City of San Antonio

Planning Commission

Minutes

****Planning Commission Technical Advisory Committee****

Figure 5.3.1

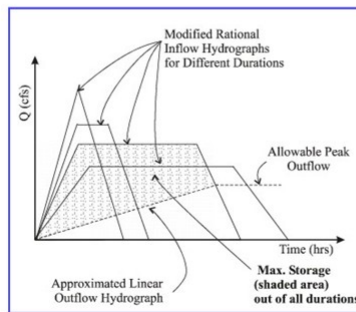
Sabrina Santiago, Public Works, stated the request is to provide guidance regarding Modified Rational Method.

5.3.1 – Modified Rational Method General Guidance

The MRM is an adaptation of the rational method which allows the designer to calculate the storage volume required for a small detention basin for watersheds less than 20 acres. In this procedure, the post-development peak flowrate is applied to the time of concentration of the basin to create a triangular hydrograph. (Figure 5.3.1). A series of trapezoidal hydrographs are created for storm durations longer than the time of concentration. The peak flowrate for these hydrographs is determined by the intensity for that duration from the rational equation and occurs at the original time of concentration. The duration which produces the greatest difference in volume between the pre-development peak flow and post-development hydrographs becomes the critical duration, and this volume represents the maximum storage volume.

[Figure 9.3.4 From San Antonio River Basin Natural Channel Design 2013. Reprinted with permission from Stream Mechanics. Adapted from Rosgen \(1997\)](#)

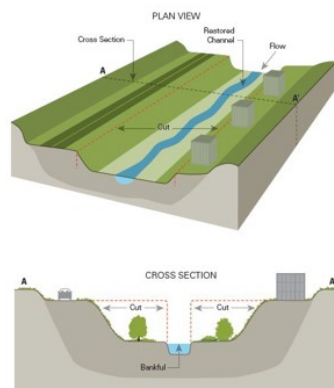
Sabrina Santiago, Public Works, stated the request is for guidance on Nested Channel Design.

The constructed channel geometry may be triangular, rectangular, **irregular**, or trapezoidal in shape. [A new or restored constructed earthen channel may be designed as a "nested channel" using the Priority 3 restoration design approach specified in the San Antonio River Basin Natural Channel Design Protocol \(See Figure 9.3.4 below\).](#) The side slopes should not exceed the requirements in 9.3.3.1 or 9.3.3.2. In areas where traffic safety may be of concern, the channel side slope should be 4H:1V or flatter or other vehicular protection devices may be required.
